<b>Grid Code</b> <b>Modification Proposal Form</b> Email to <a href="mailto:gridcode@eirgrid.com">gridcode@eirgrid.com</a>			
<b>Title of Modification Proposal:</b>  <b>MPID 293 DSU Maximum Down Time</b>  <b>MPID (EirGrid Use Only): 293</b>			
<b>Date:</b>	13 October 2021		
<b>Company Name:</b>	DRAI		
<b>Applicant Name:</b>	Paul Troughton		
<b>Email Address:</b>	<a href="mailto:paul.troughton@enel.com">paul.troughton@enel.com</a>	<b>Tel:</b>	
<b>Grid Code Version:</b>	9		
<b>Grid Code Section(s) Impacted by Modification Proposal:</b>	CC.7.4		
<b>Modification Proposal Justification:</b>  <p>In 2007, when provision for Demand Side Units (DSUs) was added to the Grid Code, all Demand Side Units were eligible to be paid the same for their availability through the Capacity Payment Mechanism, regardless of their performance characteristics. It was therefore necessary for the Grid Code to establish a minimum set of performance characteristics so that all capacity provided by Demand Side Units was of similar value. One of these requirements was that all Demand Side Units must have a Maximum Down Time no less than 2 hours.</p> <p>The SEM Committee's decision SEM-18-030, in June 2018, has cha

The various DSU performance parameters illustrated in the diagram below, taken from CC.7.4:

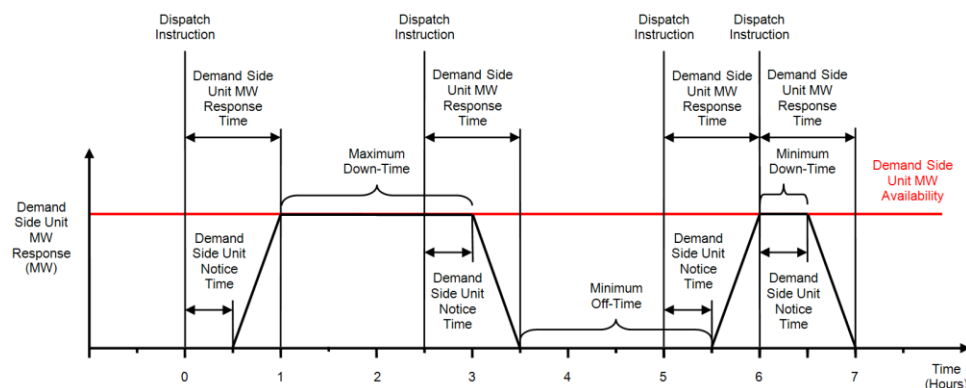
It may be worth clarifying that this diagram is only an example of a DSU where the Maximum Down Time just happens to be 2 hours, but this is not strictly necessary, as it is already possible to create DSUs with longer Maximum Down Times.
